Report to Sydney West Joint Regional Planning Panel

JRPP No.	2015SYW012
DA No:	JRPP-14-2628
Proposed Development:	10 Storey Mixed Use Development - Retail/Commercial and Residential Flat Buildings
Development Type:	Capital Investment Value > \$20 million
Lodgement Date:	24 December 2014
Land/Address:	Lot 1 DP 883859, No. 1 Zoe Place, Mount Druitt
Land Zoning:	3(a) General Business under Blacktown Local Environmental Plan (BLEP) 1988 B4 Mixed Use under Blacktown Local Environmental Plan (BLEP) 2015
Capital Investment Value of Approved Development:	\$67,784,615
Applicant:	Ausunion First Group Pty Ltd on behalf of Vollandu Pty Ltd
Report Author:	Holly Palmer – Senior Project Planner
Instructing Officers:	Judith Portelli, Manager Development Assessment Glennys James, Director Design and Development
Date Submitted to JRPP:	7 August 2015
Date Considered by JRPP:	20 August 2015

ASSESSMENT REPORT

Figure 6 Plan showing right of carriageways

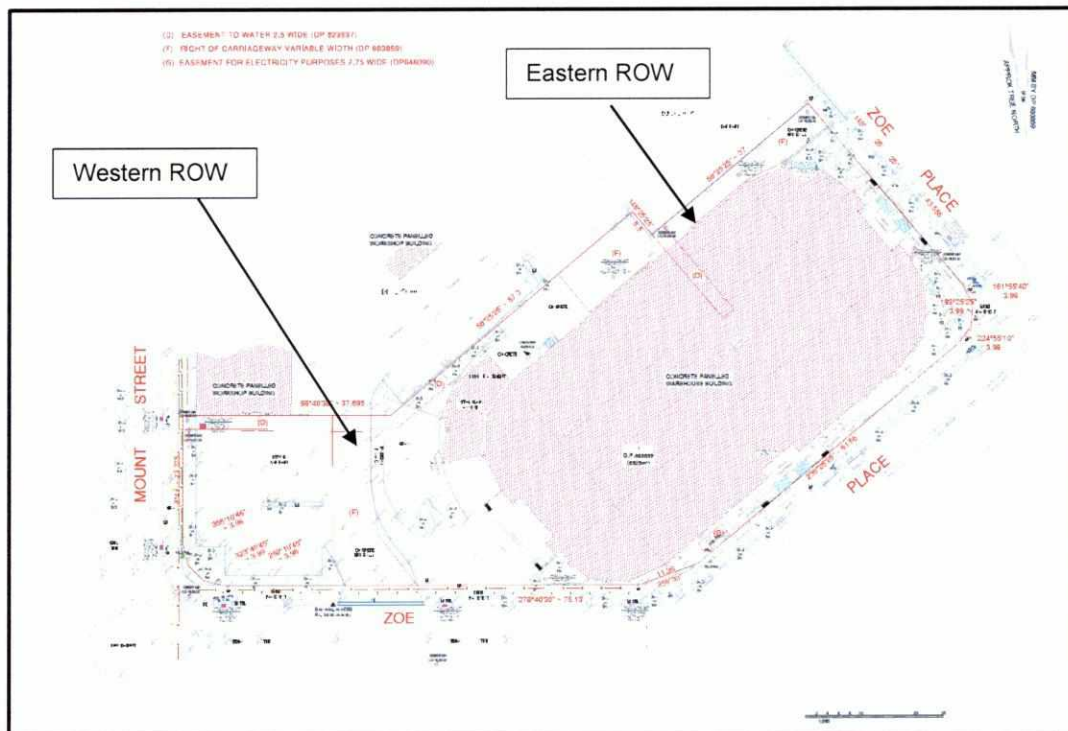
The subject site is burdened by 2 existing right of carriageways (ROWs) of variable width which benefit the adjoining lots to the north. The DA proposes to build over the western ROW (near the corner of Zoe Place and Mount Street) and retain a 4.5 m high clearance above the ROW. The proposal will maintain access over both ROWs during works, and also maintain vehicular access to the adjoining properties. The ROWs are shown on the plan below.

This application is supported by legal advice which was prepared for the applicant by Gadens Lawyers (**Attachment 8**) which advises that:

- The applicant is entitled to build over the ROW but not so as to obstruct the use of it.
- The proposed development provides a 4.5 m clearance over the western ROW to be used by individuals on foot and in vehicles, which does not present a 'substantial interference' with the use of the ROW and therefore would not infringe upon the rights granted under the ROW.
- The dimensions of heavy vehicles in NSW are governed by national regulations and cannot exceed 4.3 m in height, with the exception of vehicles intended to carry large livestock or automobiles. Therefore the ROW will continue to be able to be used by vehicles and ultimately for all purposes for which the ROW was granted.

This application is not supported by formal written consent from the adjoining property owners. However, the applicant has advised that they are presently negotiating the approval with the 3 beneficiaries to the ROWs and so are amenable to a condition of consent being imposed which requires formal written consent to be provided to Council confirming that they support the development being constructed over the ROWs with a

minimum clearance height of 4.5 m. It is also noted that, should the written consent of the 3 beneficiaries not be provided, the applicant may approach the Supreme Court under common law to seek redress.

We consider this arrangement to be acceptable, and recommend that the matter be dealt with via a deferred commencement condition. The condition will require the formal written owner's consent being provided to Council from the beneficiaries of the existing ROWs that they permit the development to be undertaken over the ROWs. This amendment is also to be reflected on the deposited plan and Section 88B instrument for the subject land (**Conditions 1 and 10.1.9**).

Figure 7 Extract of the proposed 'Building A Level 4 - 8 Plan' which demonstrates the proposed measures in response to the reduced building separation.

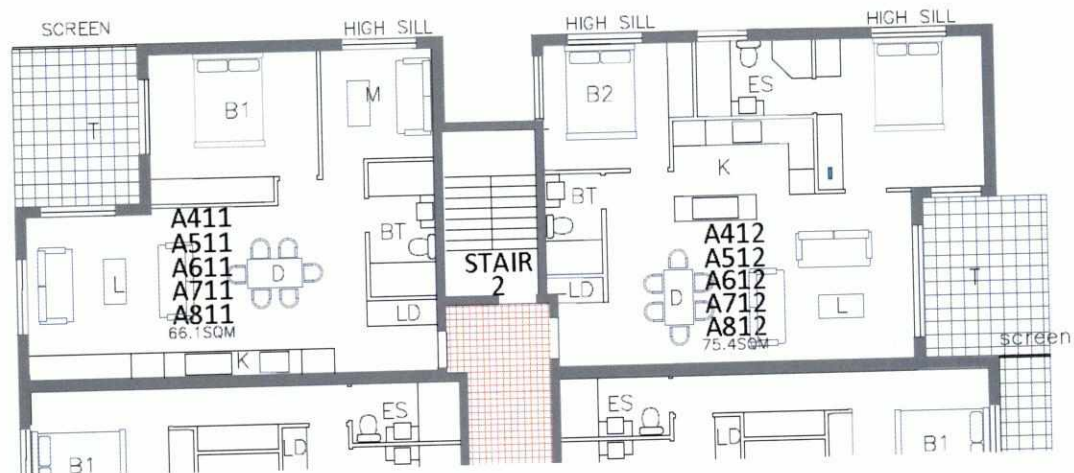
The proposal satisfies the minimum 6m side and rear setback (to the northern boundary) for all building elements above the podium level (Levels 2 to 10). To further protect the visual and acoustic amenity of the future occupants and the future redevelopment of the adjoining property, the applicant has also provided privacy screening measures. These measures are demonstrated in Figure 6 below, which is an extract of the proposed 'Building A, Level 4 - 8 Plan', which has a building setback from the northern boundary of 6 m, which satisfies the minimum DCP requirements. The proposal seeks to mitigate potential adverse privacy impacts on the adjoining site by providing highlight windows and screening measures to orientate the openings away from the adjoining site.

The proposal satisfies the minimum building setback to the northern boundary as required by BDCP 2006 in relation to developments in a sub-regional centre context and is satisfactory.
